ND-2012-0017  
March 13, 2012

Subject: **PSEG Early Site Permit Application**  
**Docket No. 52-043**  
**Supplemental Response to Request for Additional Information, RAI**  
**No. 40, Aircraft Hazards**

**RESPONSE to RAI No. 40**

**QUESTION No. 03.05.01.06-1, Item 2**

**CD-ROM Containing Revised SSAR Figure 2.2-2**

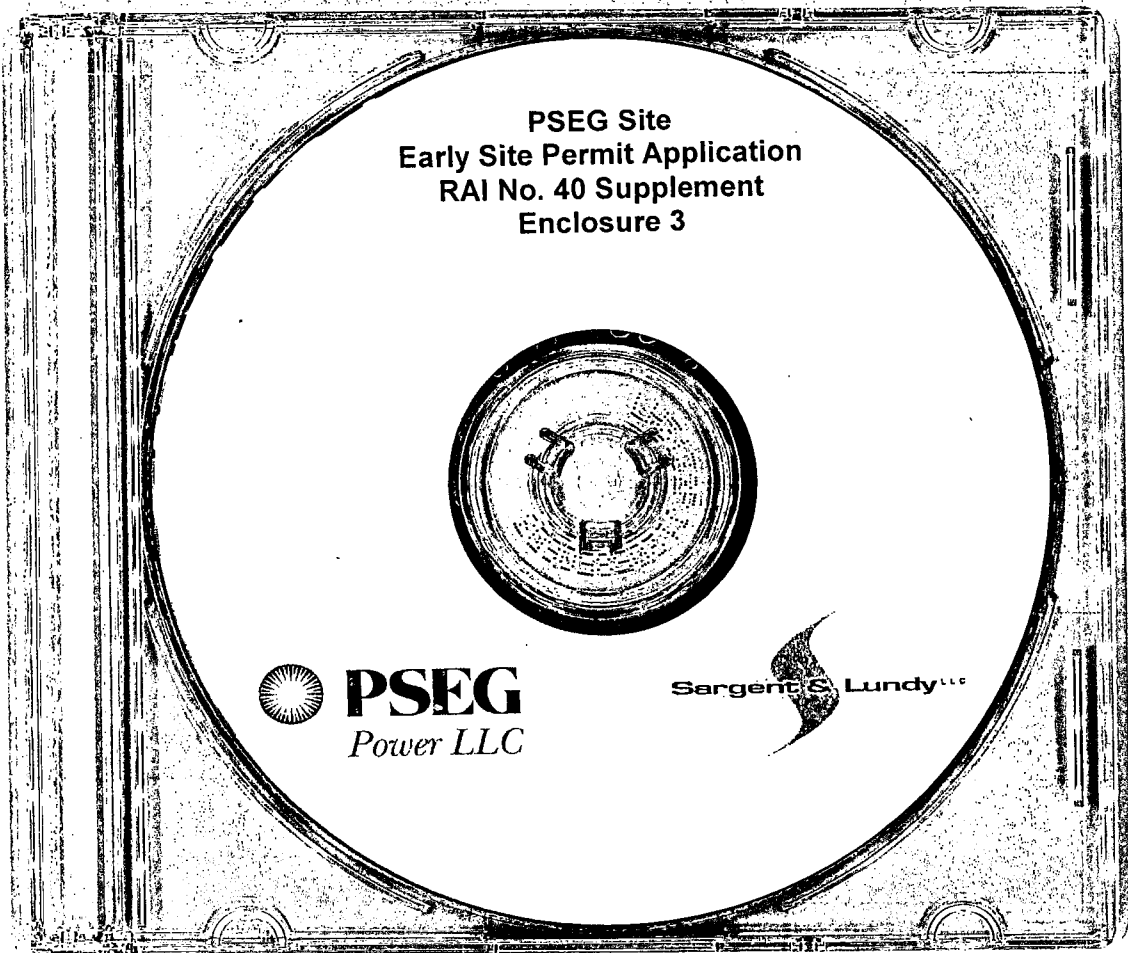
SSAR Subsections 2.2.2.7.2 and 3.5.1.6.2 and Table 3.5-5 and Figure 2.2-2 will be updated and new Tables 3.5-6 and 3.5-7 will be added as specified in Enclosure 2 of this document. Revised SSAR Figure 2.2-2 is provided in Enclosure 3

No industrial growth projections are available for Salem County. However, the Salem County Utility Development Business Project is the closest military routes are 6 slow speed low-altitude military training routes as indicated on Figure 2.2-2 (SR800, SR805, SR844, SR845, SR846, and SR847). The nearest edges of these military training routes are located within five statute miles of the PSEG Site.
